68HC908BD48MSE1

Mask Set Errata 1

68HC908BD48 8-Bit Microcontroller Unit

GLITCH ON TIMER BUFFERED PWM OUTPUT

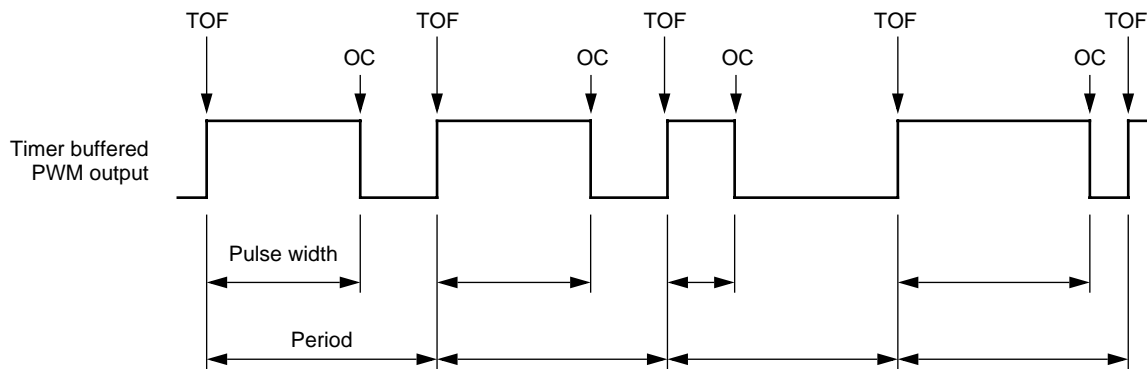
In timer buffered PWM operation, when a timer overflow (TOF) event or an output compare (OC) event coincides with a write to either pair of the timer channel registers (TCHxH/L), the duty cycle at the PWM output glitches to 0% or 100% momentarily, then returns to proper operation.

The figure below shows a typical timer buffered PWM output waveform, indicating the TOF and OC events.

Do not write to either pair of timer channel registers at:
TOF (timer overflow), or
OC (timer output compare) edges.

To avoid the glitches when changing the PWM duty cycle, do not write to either pair of the timer channel registers at the TOF or OC.

For example, in the TOF interrupt service routine: If the OC occurs near the last TOF, write to the timer channel registers after the OC; if the OC occurs near the next TOF, write to the timer channel registers before the OC. A write to the channel register high byte (TCHxH) should immediately followed by a write to the low byte (TCHxL) to avoid TOF or OC occurring between the writes. Instruction cycle times must be included when making timing calculations.
